**Final Environmental Impact Report (EIR) for the
Bay & Day Commerce Center Project (Proposed Project)
(SCH No.: 2023090050)**

Summary of Original Project Information in the Draft EIR vs. Revised Project Information in the Final EIR

South Coast AQMD Comments on the Final EIR

Figure 1: Original Project Site Plan (Draft EIR)

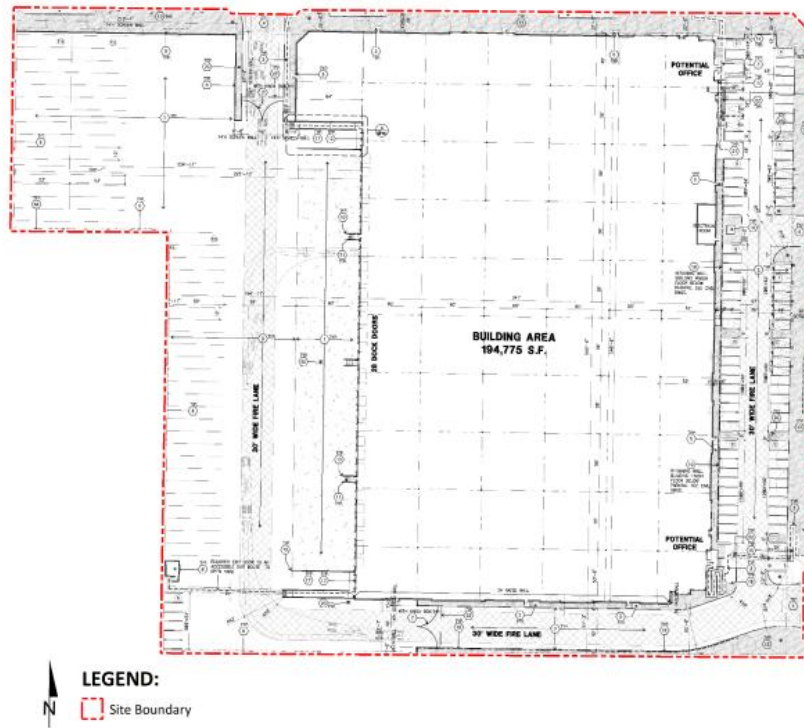
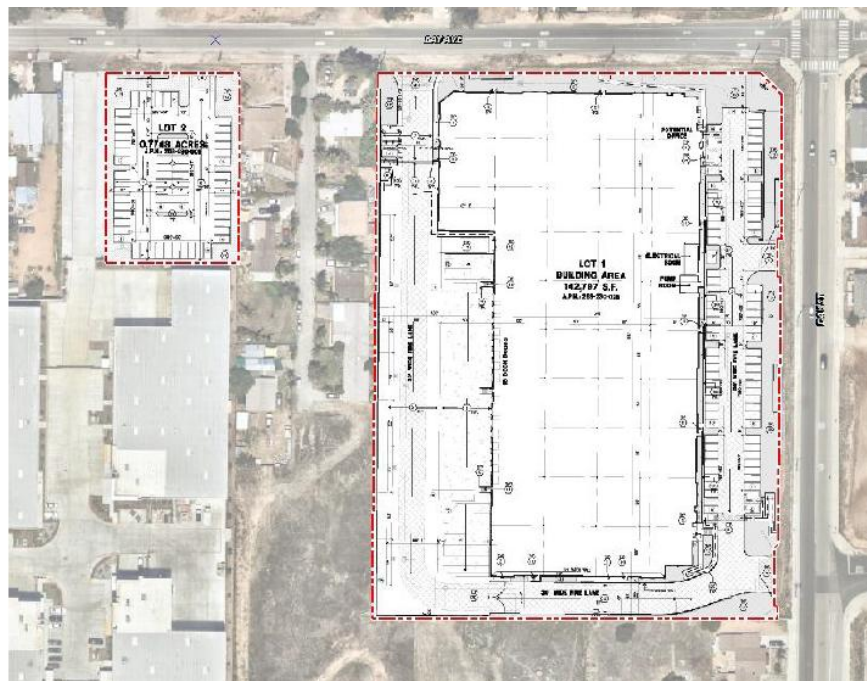
The revised site plan now excludes the parcel containing the existing residences, whereas the analysis of the Draft EIR was based on the demolition of the existing residences and use of that property for the Proposed Project. Figures 1 and 2 illustrate the original site plan in the Draft EIR and the changes to the site plan in the Final EIR. Under the revised design in the Final EIR, the existing residences, which are located within 10 feet immediately to the west of the proposed warehouse, would no longer be demolished and replaced by a parking area and instead remain intact. If the revisions to the Proposed Project are implemented, these existing residences would directly face the warehouse loading dock area, where truck loading, unloading, idling, and maneuvering activities would occur 24 hours per day, 7 days per week.

The change in layout for the revised Proposed Project represents a substantial change in receptor locations that was not previously evaluated in the Draft EIR either as part of the original project or the project alternatives. The revised site configuration places the loading dock operations within the closest proximity to the existing sensitive receptors (e.g., 10 feet). By changing the configuration of the site in the revised Proposed Project by retaining the existing residences in place, the health risk assessment (HRA) conducted in the Draft EIR should have been revised to consider these existing residences as off-site sensitive receptors since they are located within 10 feet of the Proposed Project and directly adjacent to, and facing, the warehouse loading dock doors.

- a. Reconsidering the project orientation and building layout as part of the project design or as part of the alternatives analysis to:
 - i. maximize the distance between loading dock operations and the existing residences and evaluate whether the currently proposed orientation of the loading dock and separation distance from the adjacent residences are consistent with the intent of AB 98,

- ii. reorient loading docks away from sensitive receptors, and
 - iii. incorporate other feasible design features and enhanced mitigation measures to be consistent with CEQA's impact avoidance and minimization objectives;

Figure 3: Snapshot of Current Site Condition

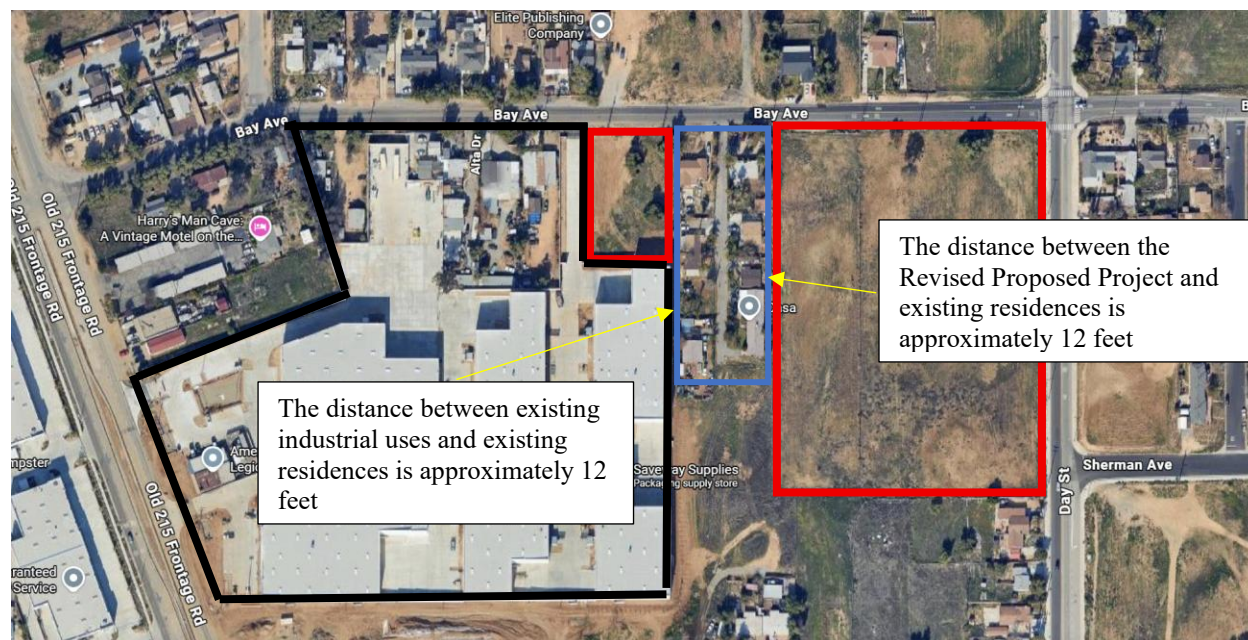
In addition, a review of recent aerial imagery indicates that there are six other existing industrial buildings which are located immediately to the western border of these existing residences. Consequently, the existing residences are situated between the revised Proposed Project on one side of the property line and an existing industrial development on the other side of the property line, resulting in a "sandwiched" land use condition for the existing residences. With this revision to the Proposed Project, these existing residences will now be potentially exposed to new sources of diesel particulate matter (DPM) from the revised Proposed Project, where none of that exposure would have occurred for the original Proposed Project in the Draft EIR. Moreover, in addition to the new project-level DPM exposures from the revised Proposed Project, these existing residences are also currently exposed to emissions from the existing industrial sources immediately adjacent to the property line. Figure 3 illustrates the proximity of the existing residences to the revised Proposed Project and the existing industrial sources. The combination of the emissions from the new sources of DPM from the revised Proposed Project with the existing emissions from adjacent industrial sources represents a new cumulative impact.

- iii. restricting truck trip generation and overall truck traffic volumes, as appropriate to reduce operational air quality impacts;
 - c. Conducting a cumulative air quality analysis on either a qualitative or quantitative basis
